## **NUCLEAR REGULATORY COMMISSION**

Title:                   Advisory Committee on Reactor Safeguards  
                              Fukushima and Reliability and PRA

Date:                  Tuesday, July 7, 2015

The SECY paper describes the staff's plans to make the requirements of the severe accident capable containment vent order, EA-13-109, generically applicable to Mark I and Mark II BWRs, and that the use of external water during a severe accident is a worthwhile benefit.

# MELCOR Results for Mark I

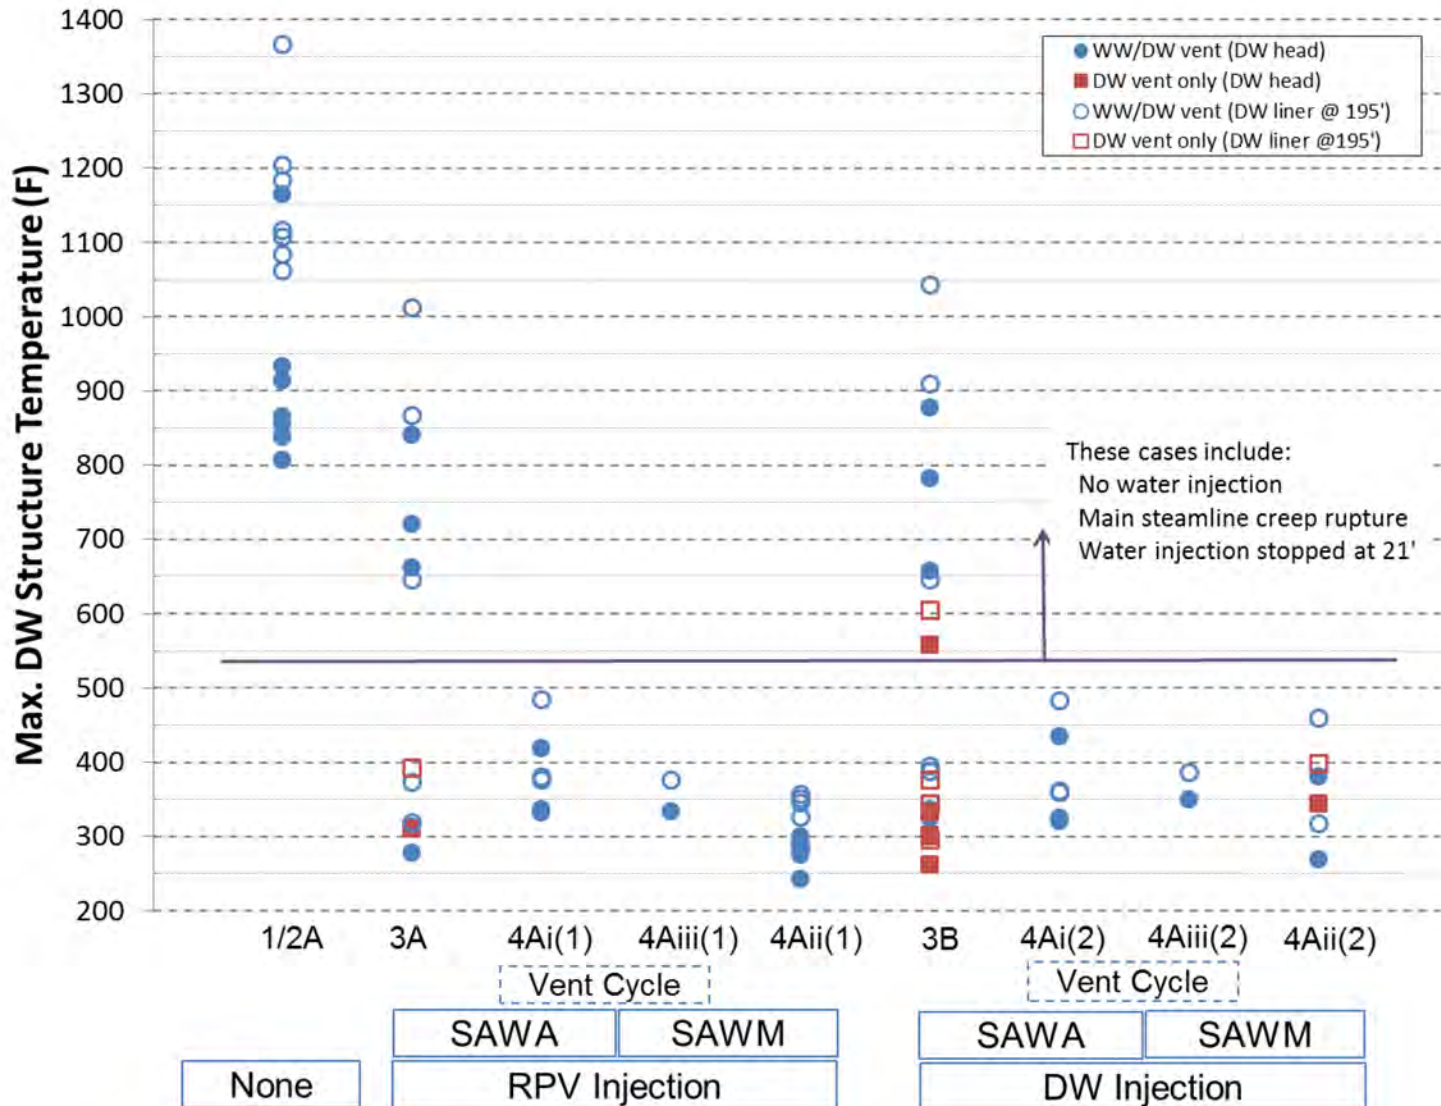
MEMBER REMPE: Before you leave this slide, so maybe I interrupted too soon, but there's a figure 4.10 in your main report that has the Mark I containment gas temperature for Case 1 and I think you have it as one of your backup slides and the peak gas temperature in the drywell pedestal area is real close to 1,900K. And it's in degrees F here which always bothers me when it goes back and forth. I think to think about it.

# Comparison to NRC Safety Goal

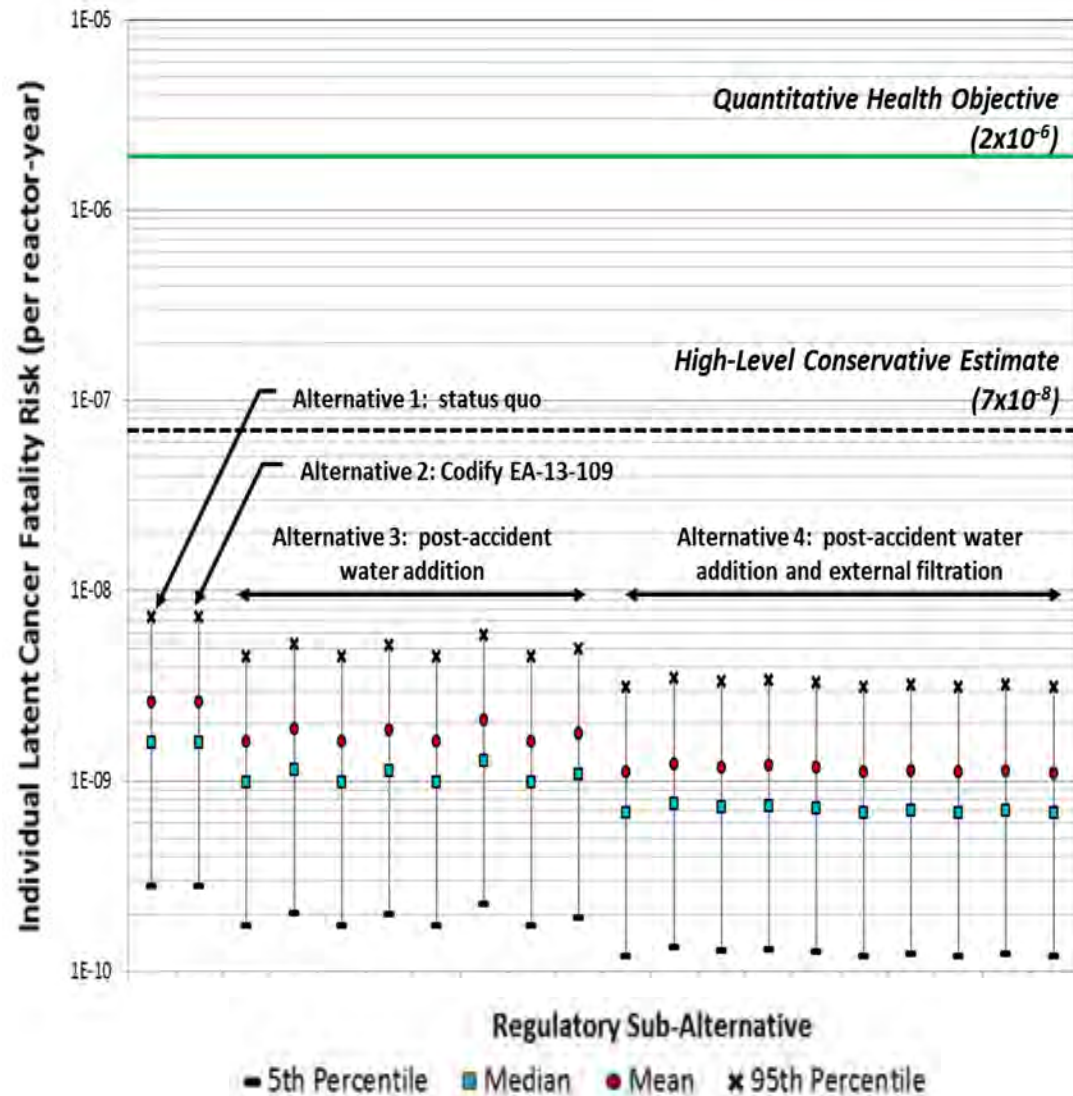
MEMBER STETKAR: I was just going to ask this, and this may be a Marty question too, but I kind of got confused when I saw this figure. I understand how the high level conservative estimate is, was quantified, okay. I understand that. This figure, I don't understand how all of the estimates with the uncertainty bounds relate to that thing.

I mean this figure forces me to compare the QHO, this high level estimate, and then all of that detail down in the bottom, and understand what they mean relative to one another. And I for one couldn't figure out how all the detail relates to the high level, what you're characterizing as the high level conservative estimate.

MEMBER STETKAR: Okay, okay. I actually understand where all the numbers come from. I just don't know how to interpret this particular figure. I understand how to interpret the figure without all of the noise in the bottom, and I understand how to interpret all of the noise on a stand-alone basis.

MEMBER STETKAR: In truth, I've thought a little bit about this. In truth, that affects a lot of the stuff that I was calling the noise on that filter, on that figure. It affects a lot of the stuff on the noise. It doesn't have a big --

If you look at that figure and take their high level conservative estimate and increase it by a factor of one and a half or so, so you make it 1E to the minus 7-ish roughly, it's still an order of magnitude more or less below the quantitative health objective.

MR. BEALL: So as it also -- as the chart also shows, the high level conservative estimate is more than an order of magnitude below the QHO, and it's also close to the COMSECY risk value for the expedited spent fuel transfer, which is the red triangle. Which is kind of going back to your question.

MR. ESMAILI: This is Esmaili. The red triangle was the highest, was the highest release and the highest consequence that we found for all the plants. This was not for Peach Bottom. This was --
